# MEMORANDUM 01

**Project:** Hepburn Springs Pavillion  
**Date:** 13.11.24  
**Pages:** 5 + 1 = 6  
**Our ref:** 7892 m01 241113 floor support.docx

## RE: PAVILLION FLOORING PROPOSAL – HERITAGE VICTORIA QUERIES.

Figure 02: Floor joist data

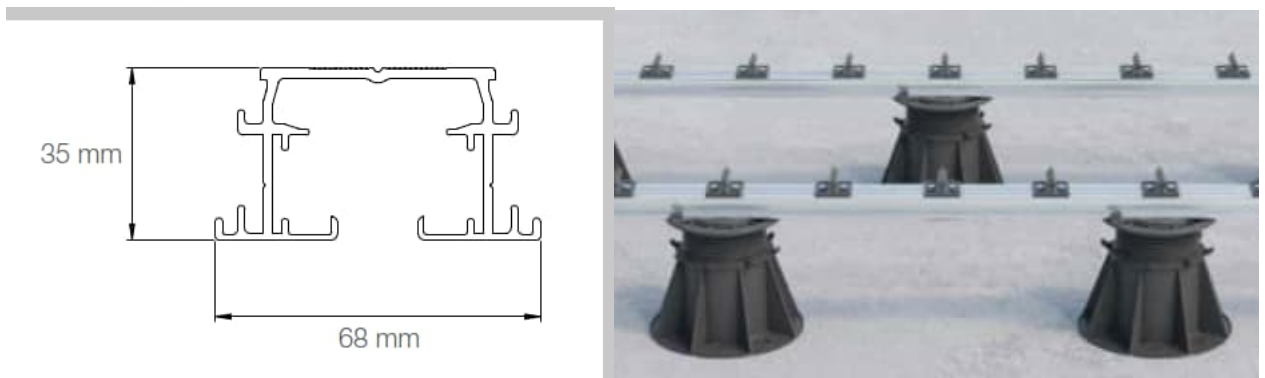
The joists you've nominated are 150x50 C-channel joists. The joists required even for a 600mm span and 600mm spacing would be much less than this. For example the standard Elmich VF aluminium joist would be OK and its only 35mm high. Refer to Figure 02.

Looking at the Elmich information, there is no standard connection detail for a 150x50 C-section. It might be possible but need to check with manufacturer. Alternatively, could use a timber section or light guage galvanised steel SHS section. Timber would need to be Durability Class 2 probably – spotted gum or similar – and that will get expensive. So I think the standard aluminium system noted is probably best for detailing and durability.

Figure 04: Suggested Jack base detail

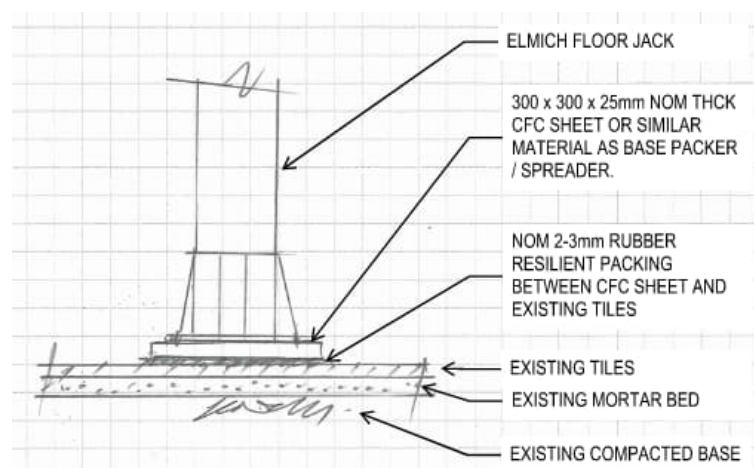
On review of the proposal for Options A & B, both would appear to have potentially unfavourable factors.

Option A, direct support of the jacks on the floor, could damage the surface of the floor if placed directly on it. If this is to be adopted, some form of protective separation and load spreading mechanism should be provided. Clearly it is not desirable to provide any form of fixing of the jack to the existing flooring.

For Option B, my understanding is that the proposal to provide the packing sand and separation layer for Option B is to even out the floor to provide a level base for the jacks. This seems unnecessary as any level differences across the floor should be able to be accommodated by the height adjustment capability of the jacks. Additionally, it is understood that the subfloor can be subject to inundation when the creek floods. For this reason, the use of timber on the floor of the subfloor may allow this material to be wet for long periods. Despite the proposed ventilation and use of marine grade ply, this is probably not a good thing for the long term durability of the ply and may affect the quality of the air in the room. I suggest using a non-organic material to support the jacks such as CFC sheet.

Also for Option B, if the subfloor is inundated, compacted sand may lose strength and move around, causing level differences in the floor. These may be able to be corrected by further jack adjustments but that would have limits and should be avoided if possible. I don't think plain sand should be used and the use of other materials such as 3% cement stabilised sand or compacted crushed rock – both of which would be much more stable – could ultimately damage the tiles during compaction or if it has to be removed.

I think a hybrid solution is therefore better as per Figure 04, ie:

- Jacks to be set on the floor but directly supported on a 25mm CFC sheet bearing plate with a layer of resilient material between the packer and the floor – for example a thin rubber sheet that will not deflect noticeably under load and will provide protection and “cushioning”. An alternative might be to use a block of freezer panel closed cell foam similar to that used under freezer slabs etc.
